NOTES FOR DISCUSSION AT DESIGN MEETING (26/10/10)

FOR THIS MEETING: QUESTIONS REGARDING BS/FM JIG DESIGN::

Confirm respective prism position: (1) or (2) or other?

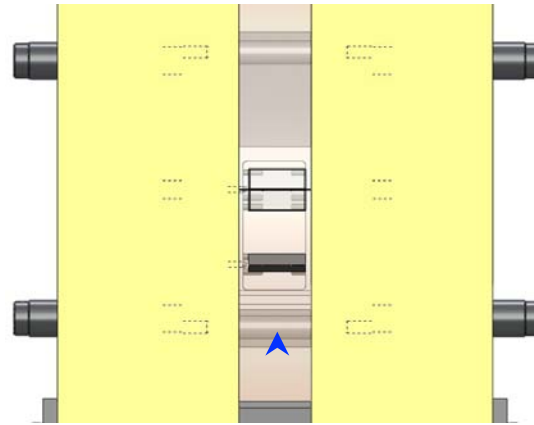
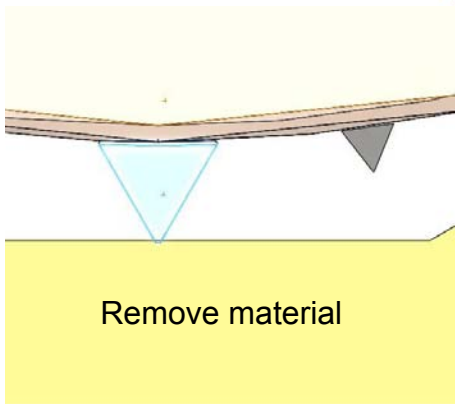
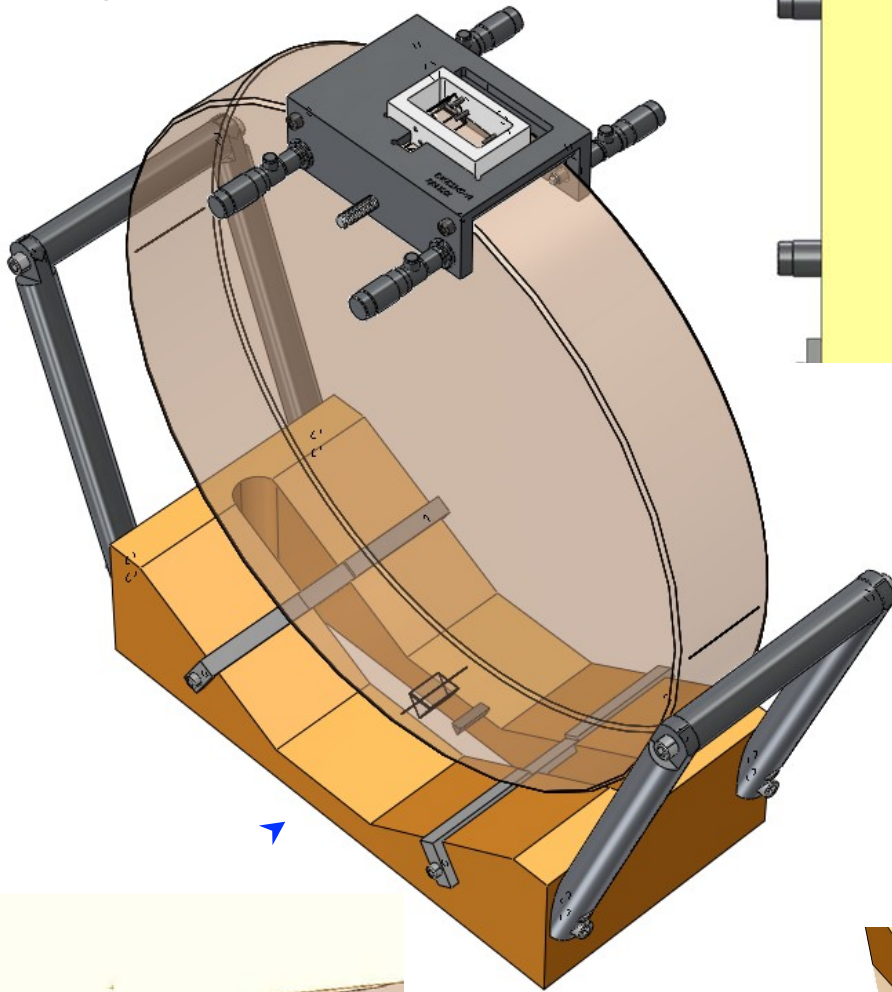
1. Confirm respective prism position (as in D1000576 & D0901076)

- main sapphire prism (D080765) coincident with COM
- secondary prism (D0902368) position – confirm respective angle.....see slides to follow (especially slide 5)

Existing v-block: modifications required

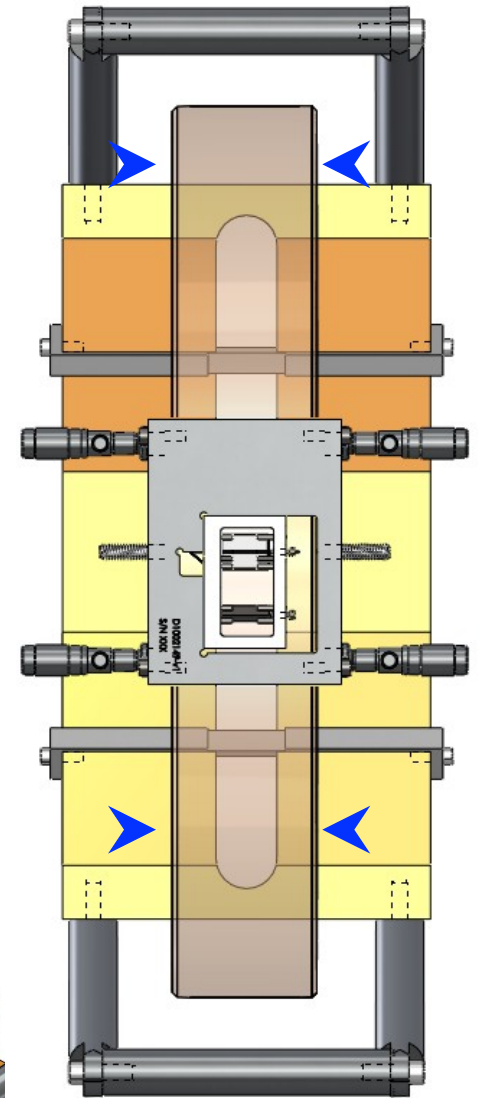
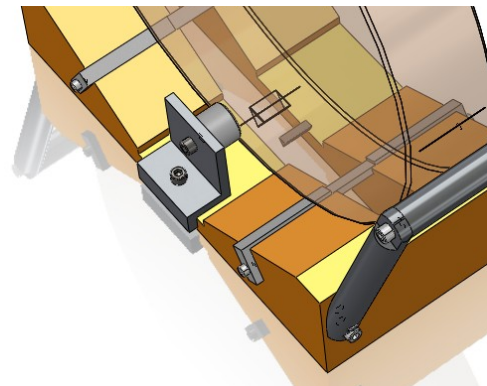
(view from below)
Increase clearance

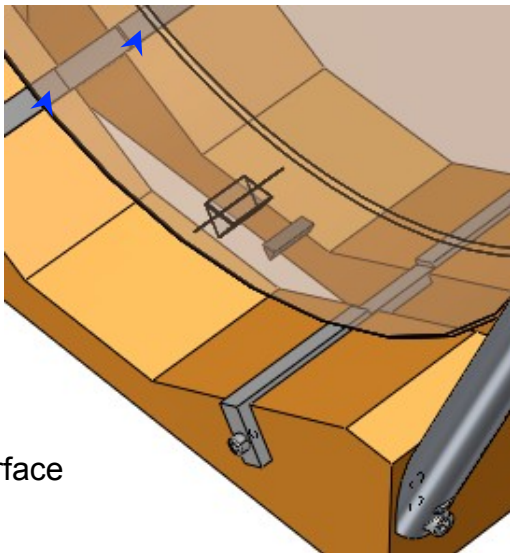
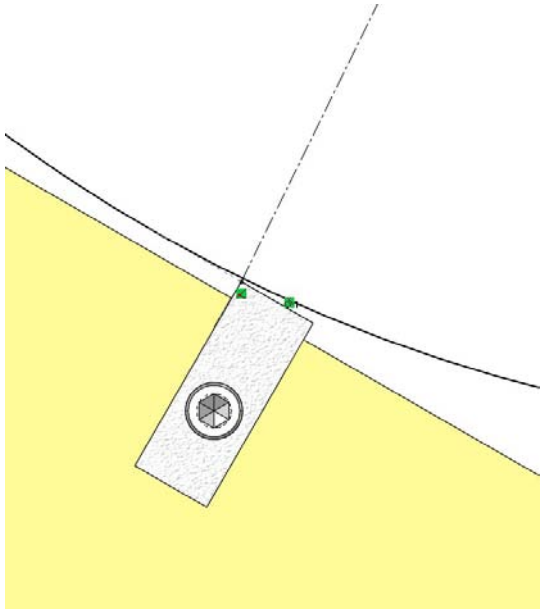
Add supports/barriers
